STEVAL-SMARTAG2 board errata

This document applies to the STEVAL\$SMARTAG2A board and corresponding firmware version FP-SNS-SMARTAG2 1.0.1

Figure 1. ST25Tap screenshots

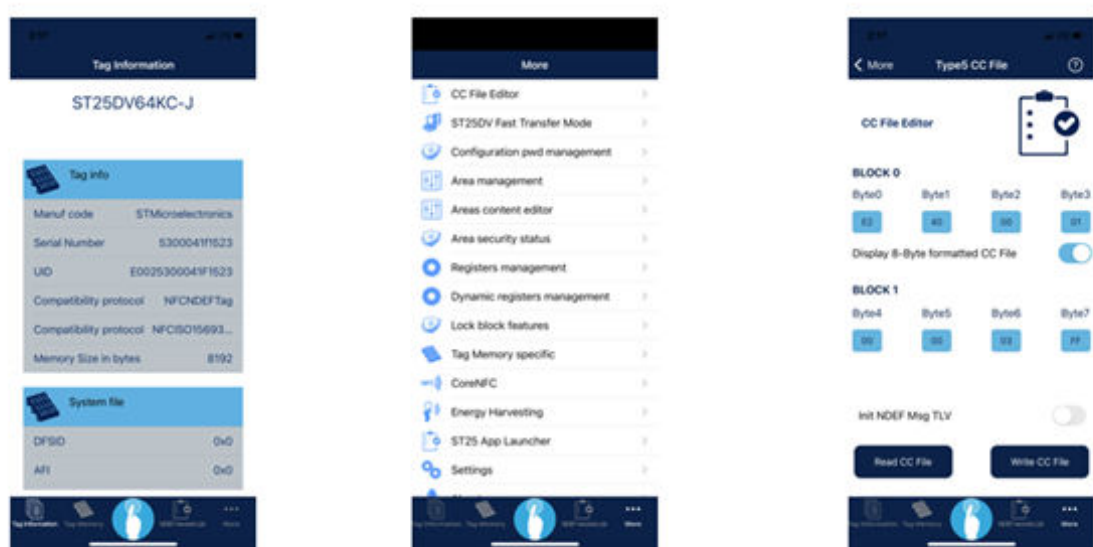
NFC EEPROM contains 4 Kb CC file instead of 64 Kb.

A non-valid NDEF does not make it possible to communicate with iOS mobile phones.

As the CC file information is set by the first firmware during industrialization, if CC File starts with E1, it is recommended to reprogram the eval board with the new firmware version FP-SNS-SMARTAG 1.0.2 available on st.com to fix the CC file issue.

The “E2 40 00 01 00 00 03 FF” array will be overwritten to the first 8 bytes in the memory.

You can also write the CC file using the NFC Tap app for iOS or ST25Tap for Android. Please follow the screenshots in the following figure for reference.

After you tap the tag, click on **[More]** at the bottom right to access the **[Menu]**. If E1 is written, make sure that you select 8-byte CC file format.

Figure 2. STEVAL-SMARTAG2 hardware modification for NFC performance

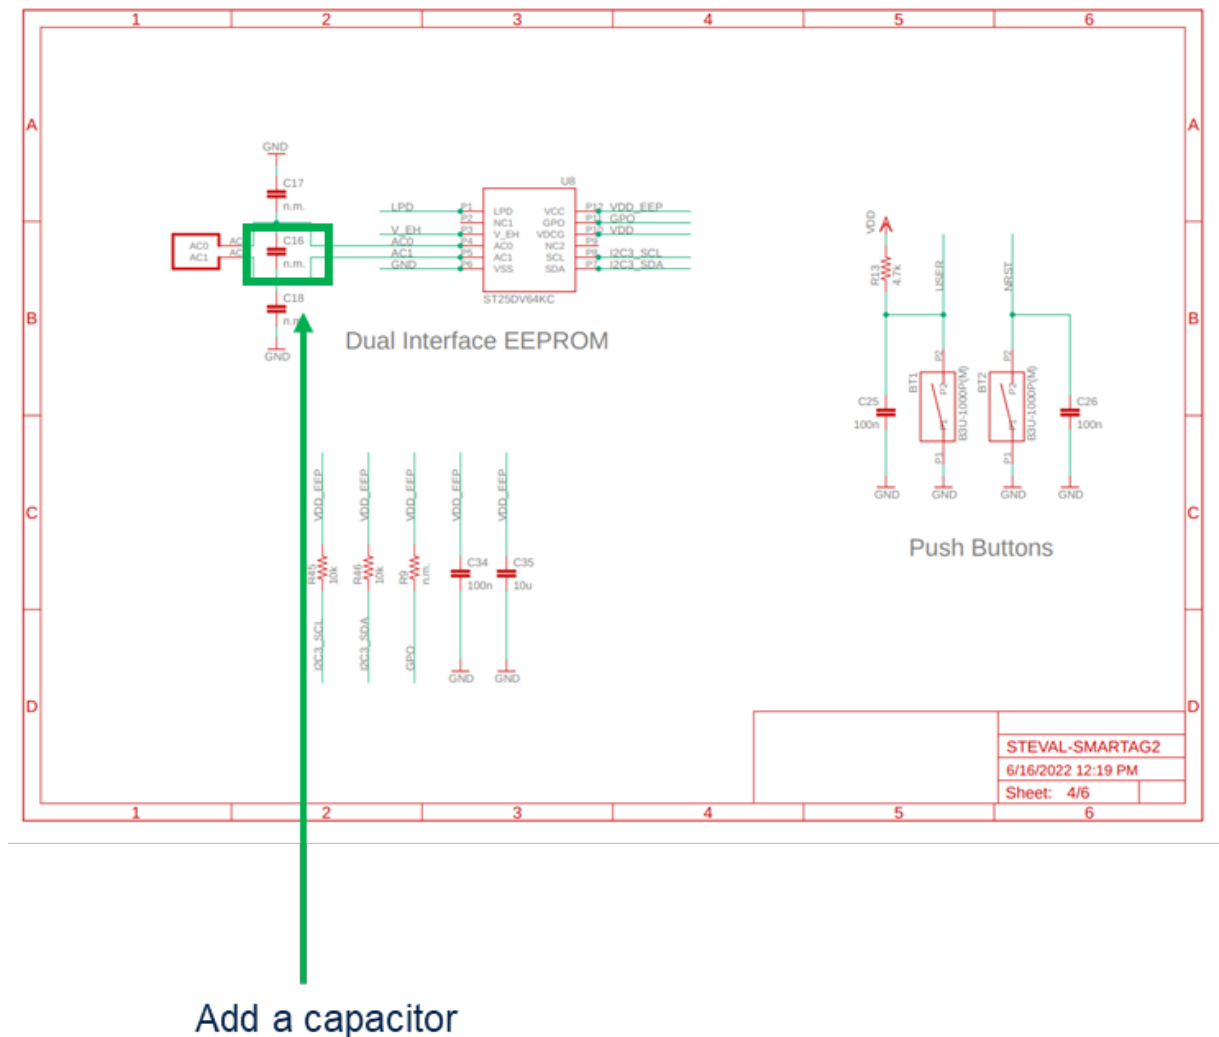
The evaluation board STEVAL-SMARTAG2 can only be read if it is in close contact with a mobile phone.

A hardware modification is required to improve NFC performance.

A 6.8 pF capacitor (i.e., C16 below) should be added on the board as shown on the schematic.

The new layout of the board will be named STEVAL\$SMARTAG2B.

Figure 3. STEVAL-SMARTAG2 hardware modification for energy harvesting

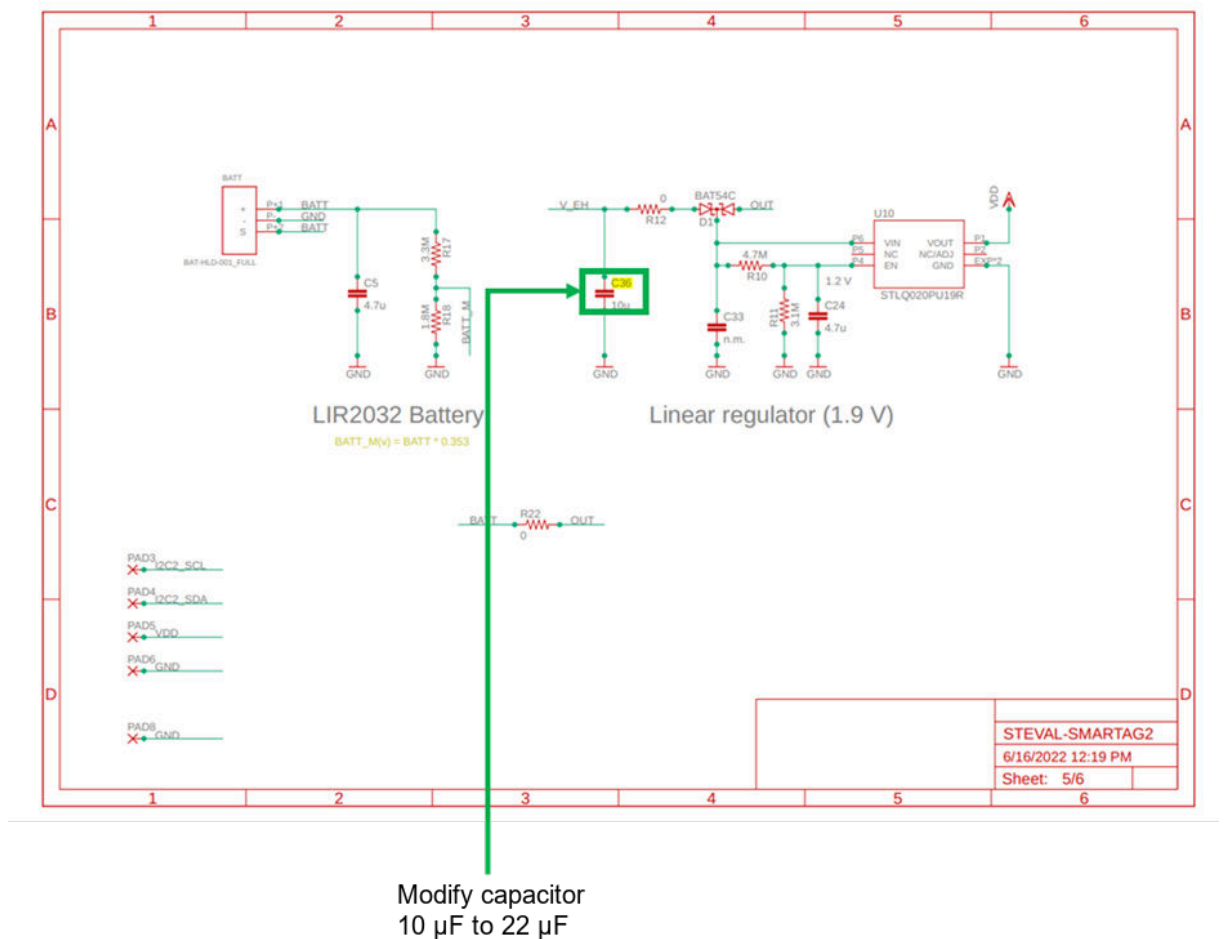
The 10 μF capacitor (i.e., C36 in the next figure) that is currently mounted on the board for harvesting mode is generally not enough to work with NFC mobile phones.

A hardware modification is required to improve the energy harvesting feature on the STEVAL-SMARTAG2 board. Replace the 10 μF capacitor with a 22 μF capacitor on C36 (see the following schematic).

The new layout of the board will be named STEVAL\$SMARTAG2B.
